**Subject: Bid Package #2**  
Abbott Middle School HVAC Replcmt-DSA 01-119556  
George Hall Elementary School HVAC Replcmt-DSA 01 119523  
Laurel Elementary School HVAC Replcmt DSA 01-119551  
San Mateo - Foster City School District

### **ADDENDUM NO. 3**

San Mateo-Foster City School District  
HVAC Replacement Scope,  
Abbott MS DSA 01-119556  
George Hall ES DSA 01-119523  
Laurel ES DSA 01-119551

DEMOLITION  
FLOOR PLANS -  
WINGS 1, 2, 3 & 4

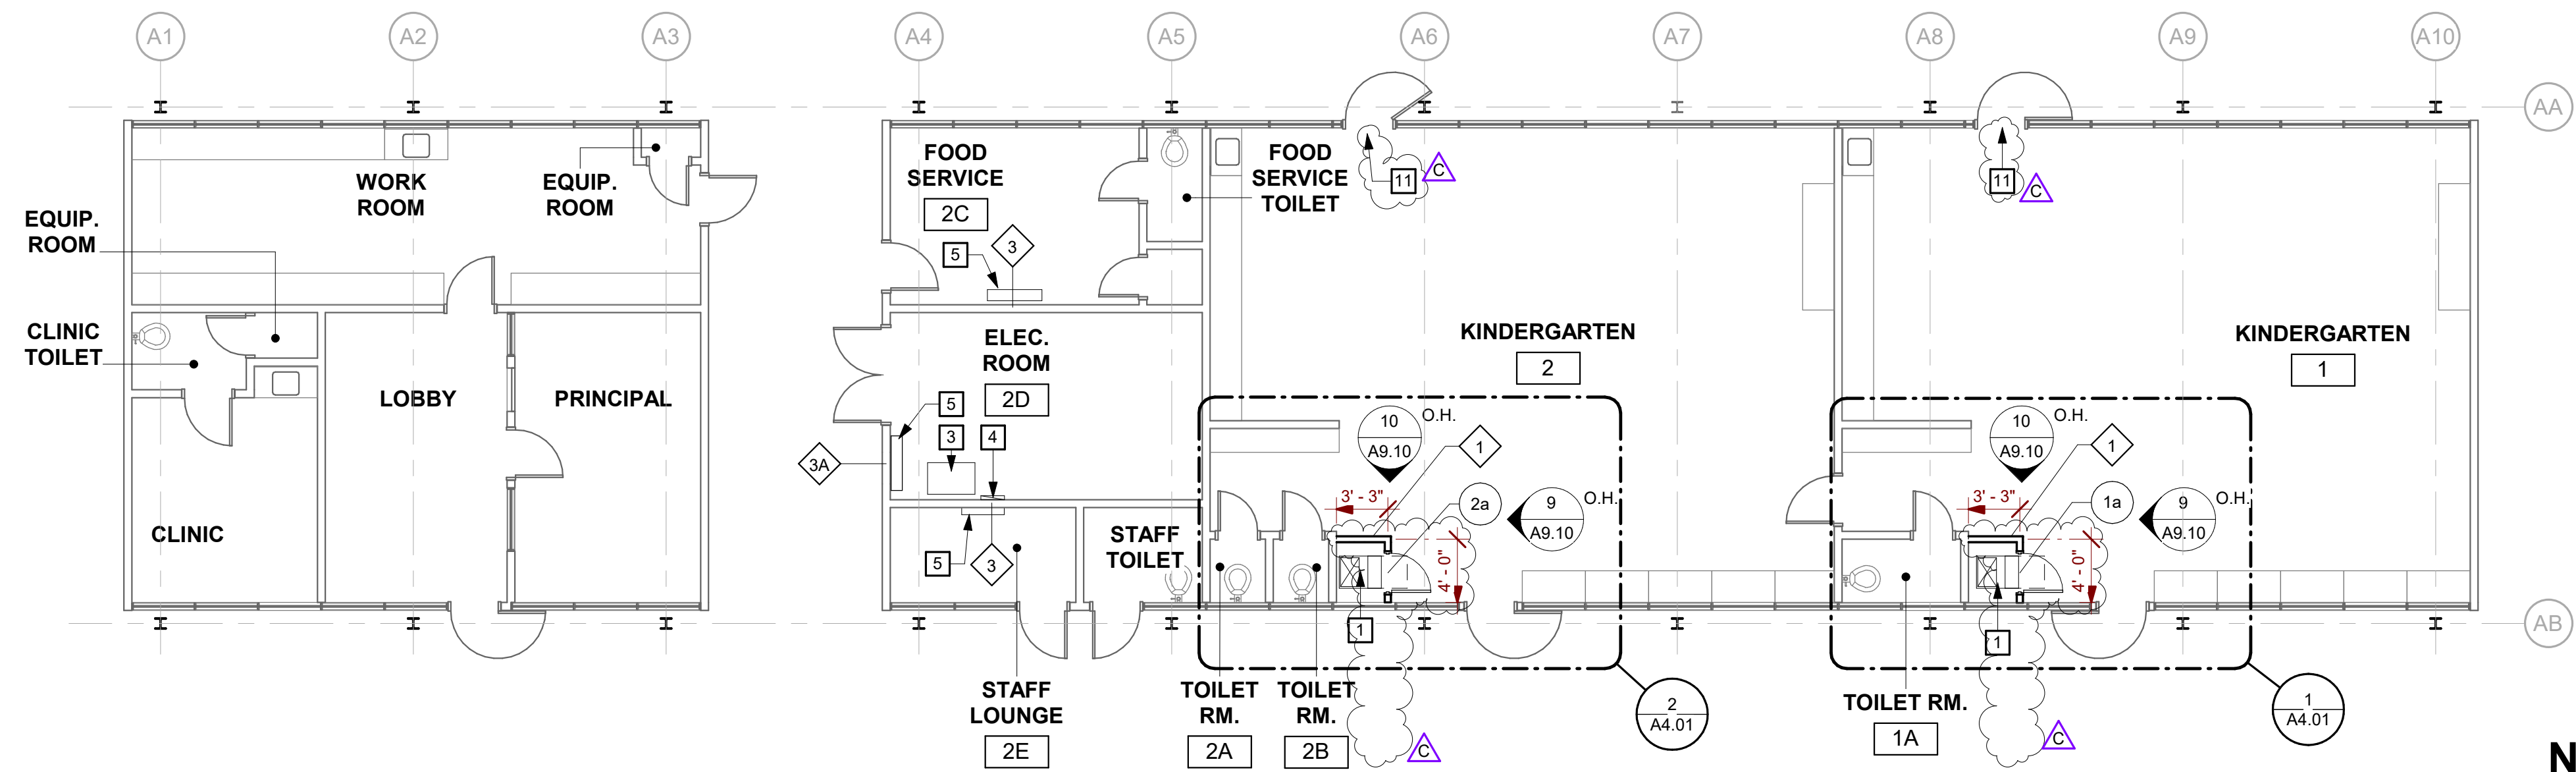
ITEM NO. 3.13:     DRAWING SHEET A2.01 – DEMOLITION FLOOR PLANS – WINGS 1, 2, 3, & 4

Revise: Demolition Floor Plan Keynote #1 per attached AD3-A2.01.

Revise: Demo and prep for drywell at locations indicated on attached AD3-A2.01.

SHEET # AD3-  
A3.01

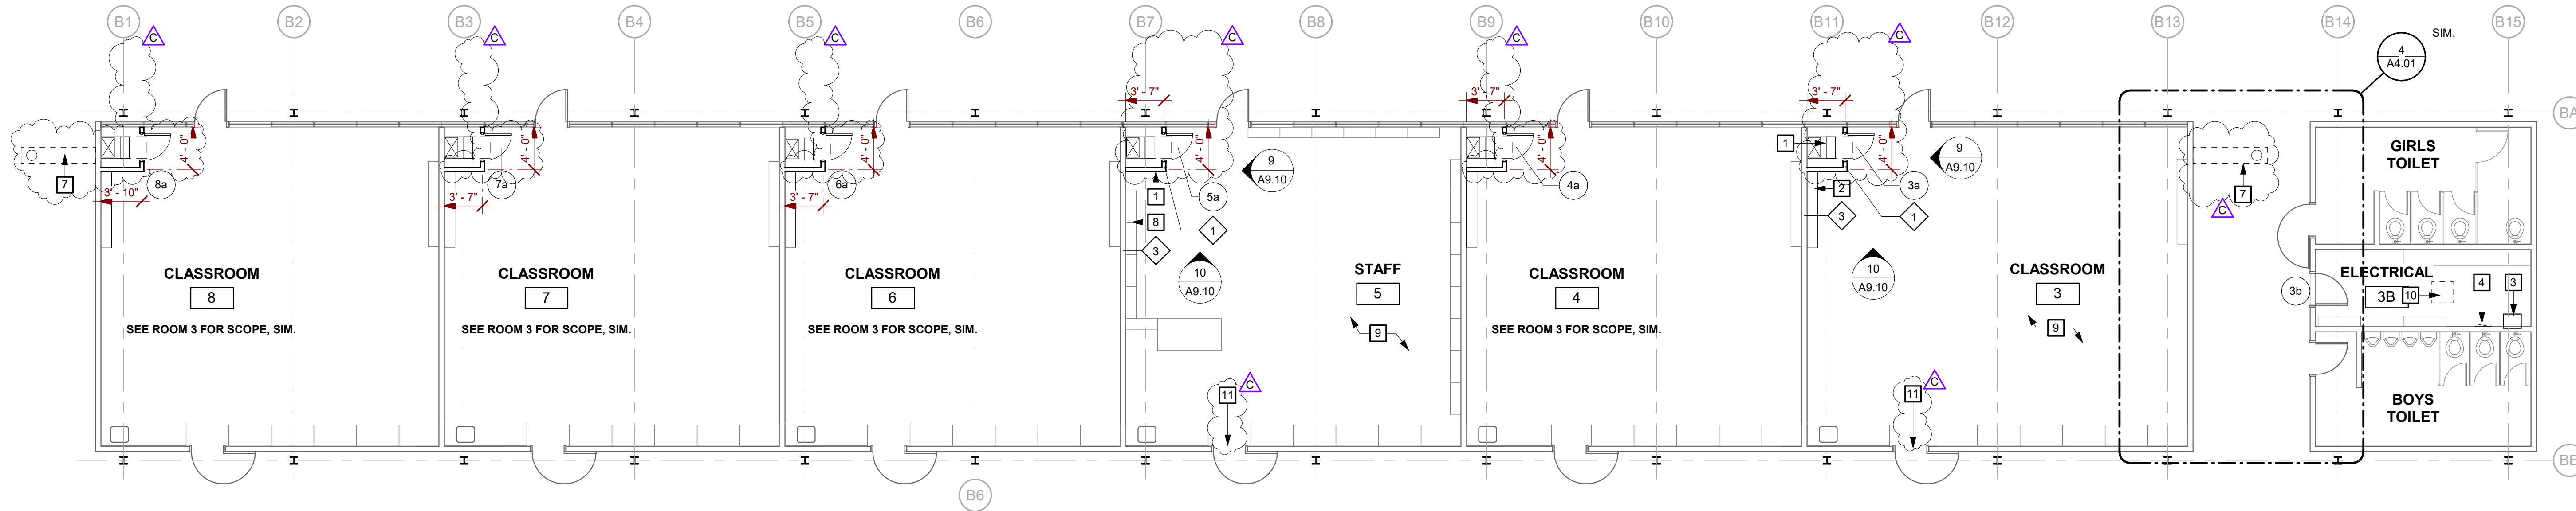
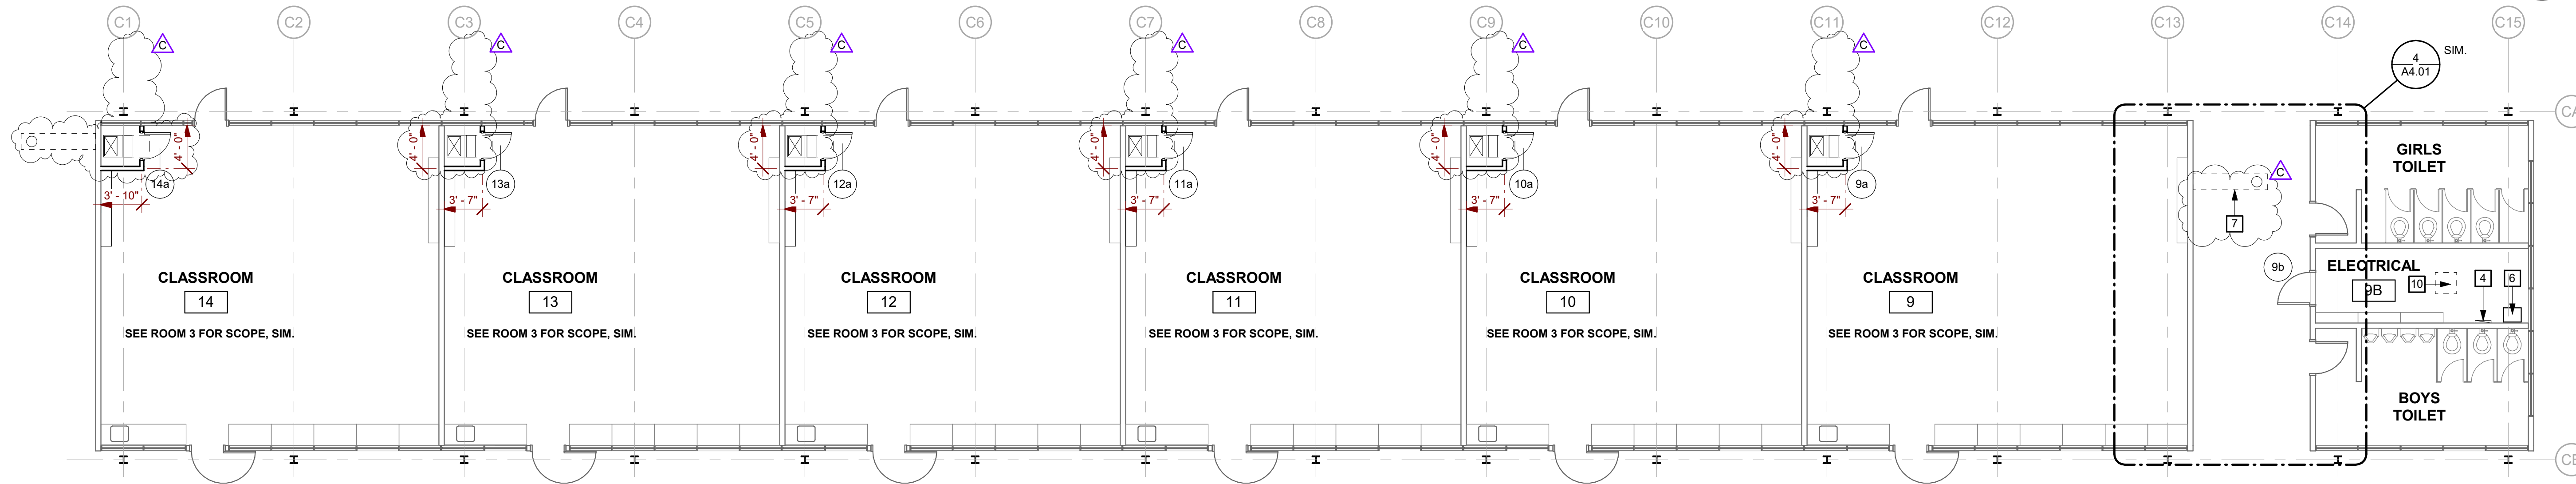
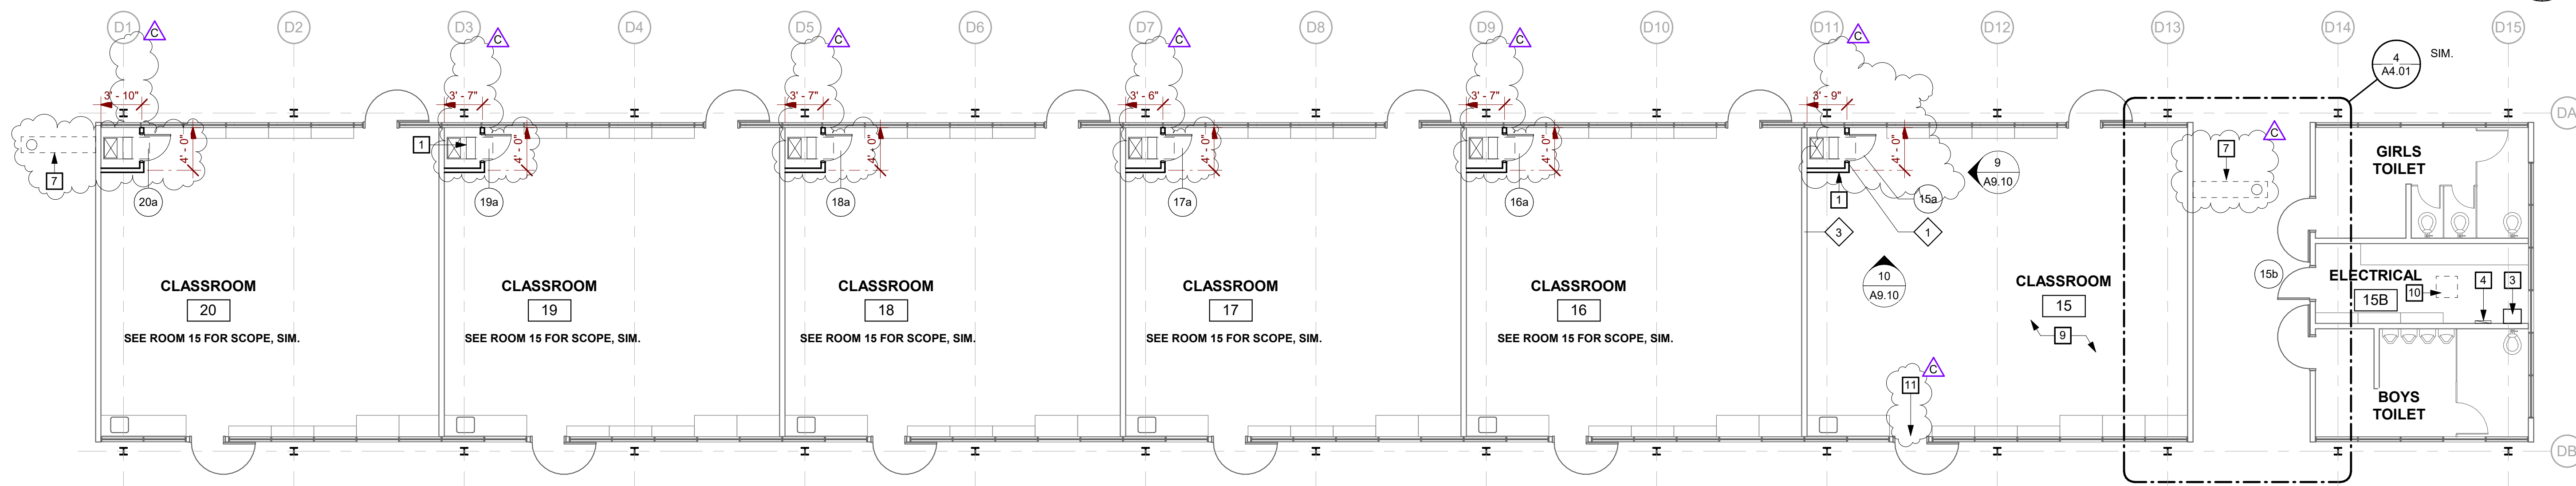
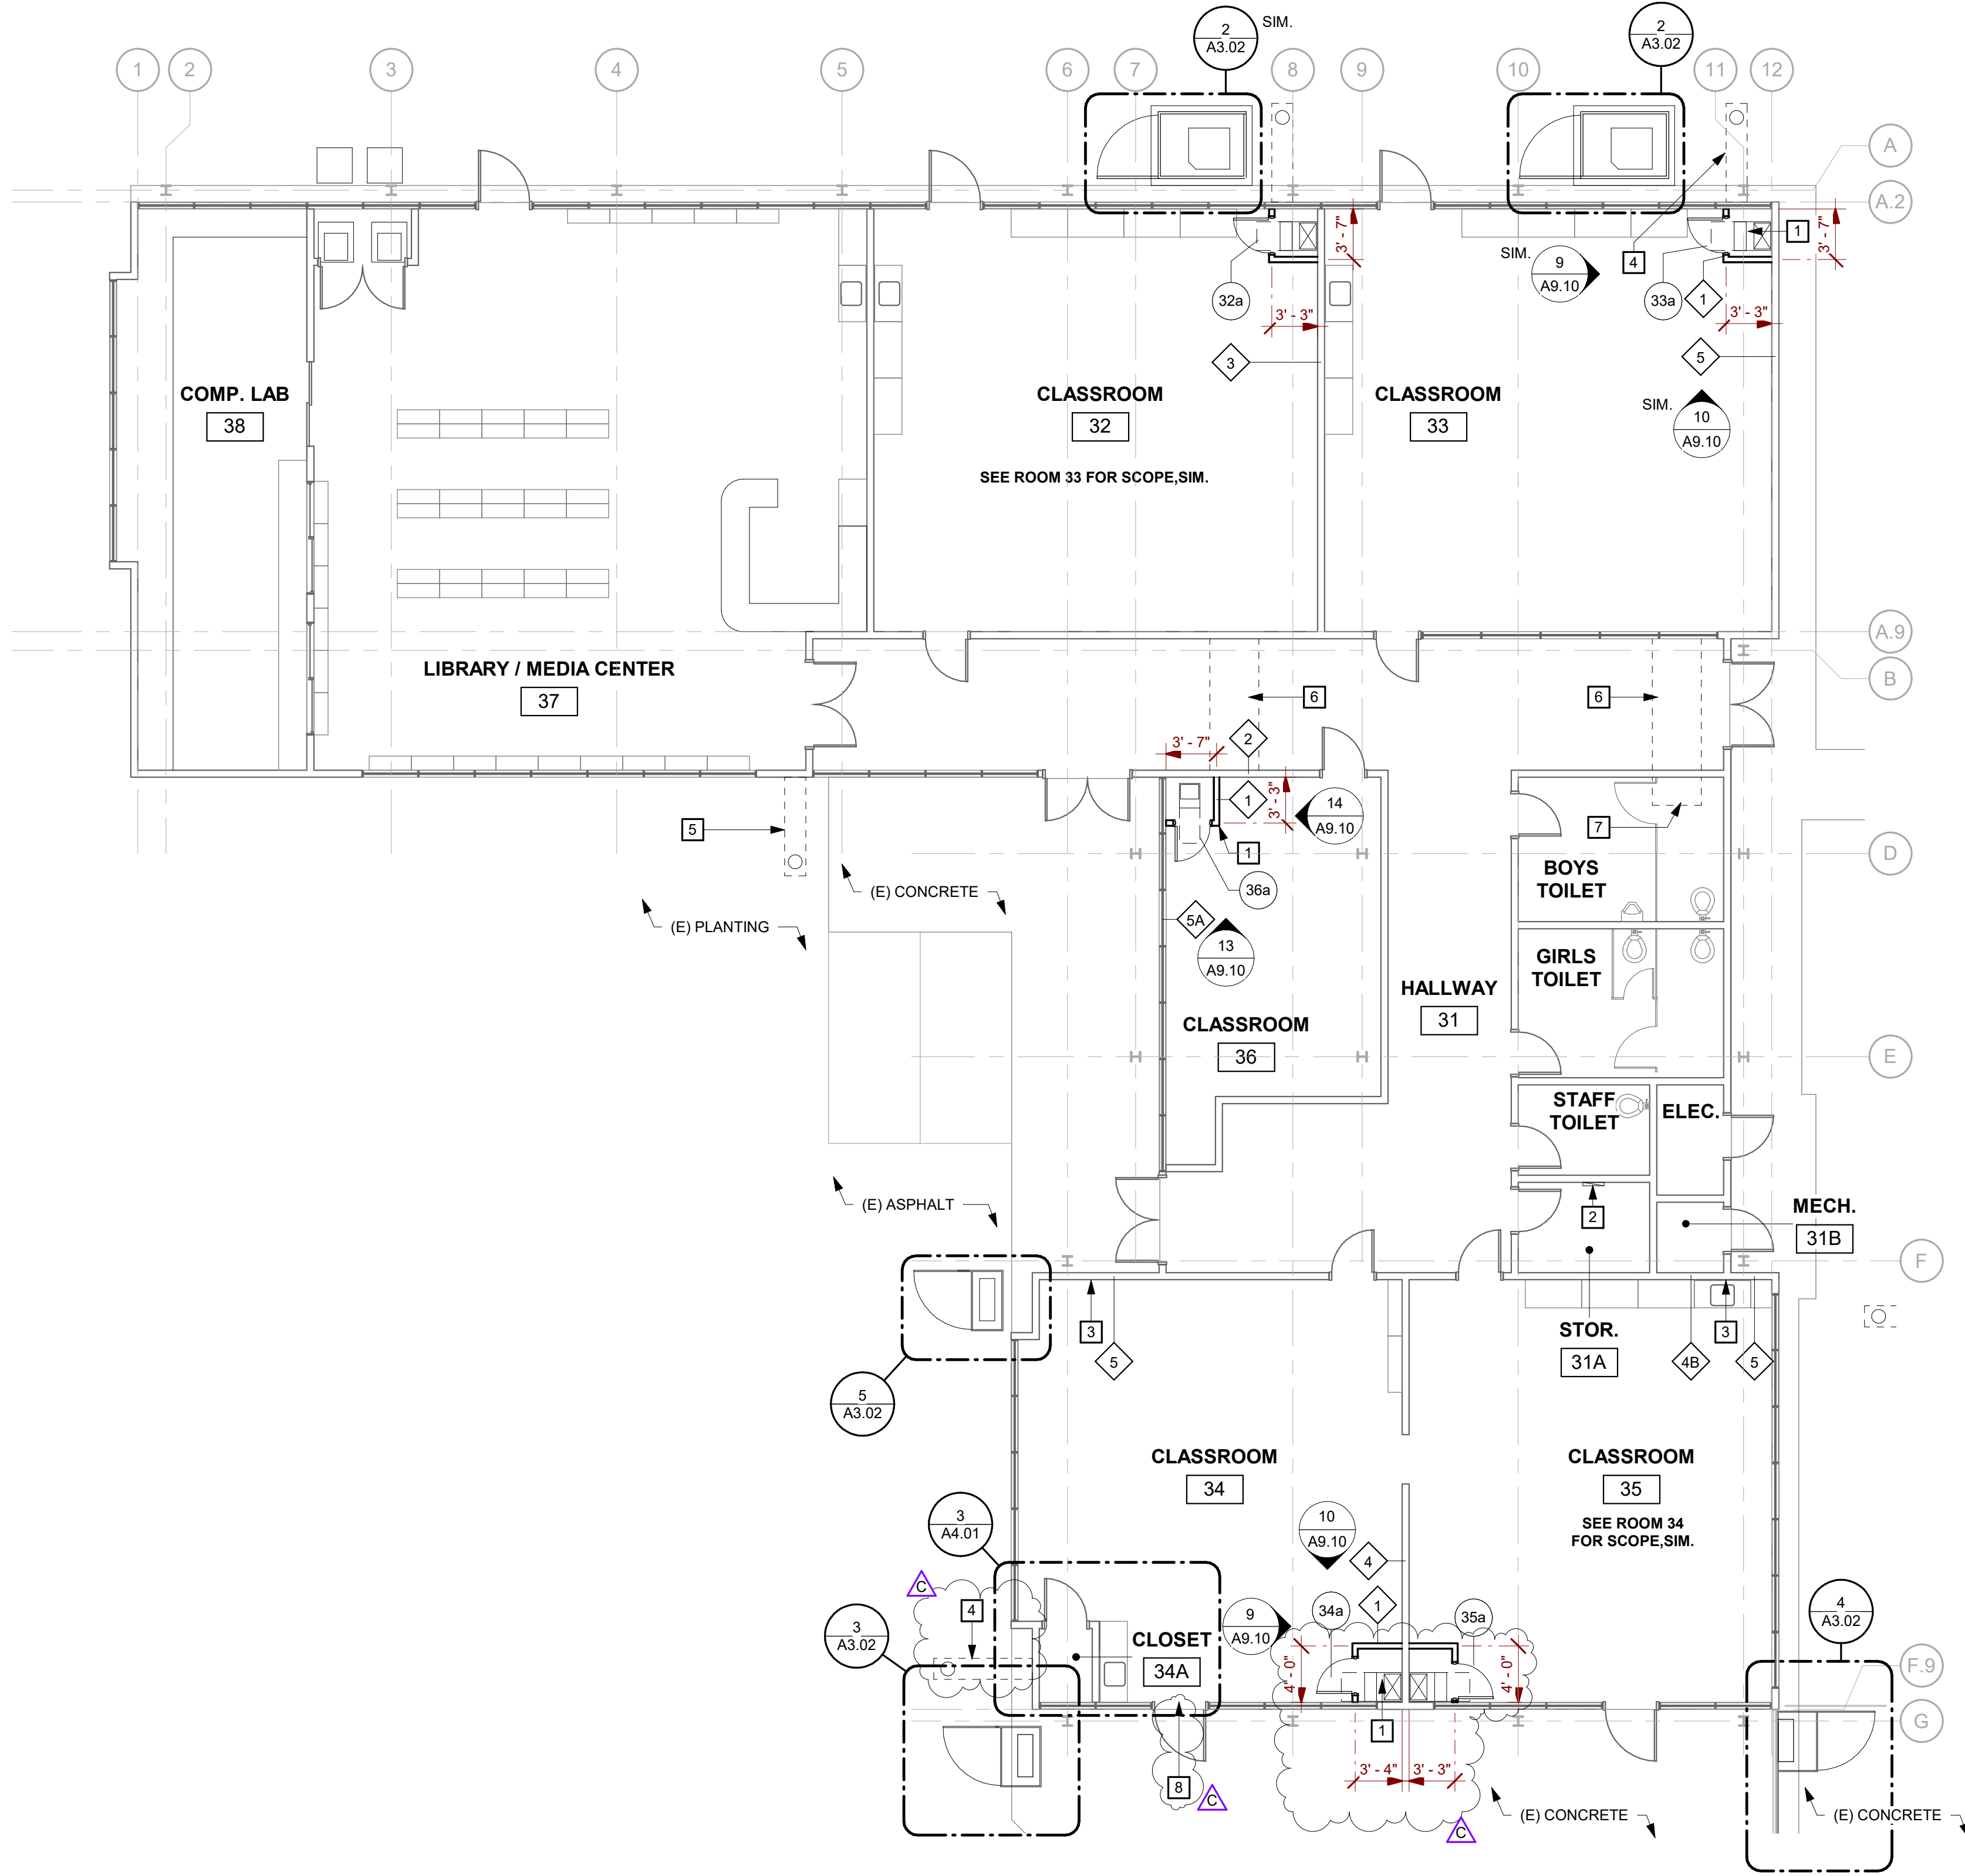
ITEM NO. 3.15:     DRAWING SHEET A3.01 – NEW FLOOR PLANS – WINGS 1, 2, 3 & 4

Add:     General Sheet Note #H per attached AD3-A3.01

Revise:     Drywell at locations indicated on attached AD3-A3.01

Add:     New Floor Plan Keynote #11 & associated tags on the new floor plan per attached AD3-A3.01

Revise:     Framing dimensions per attached AD3-A3.01
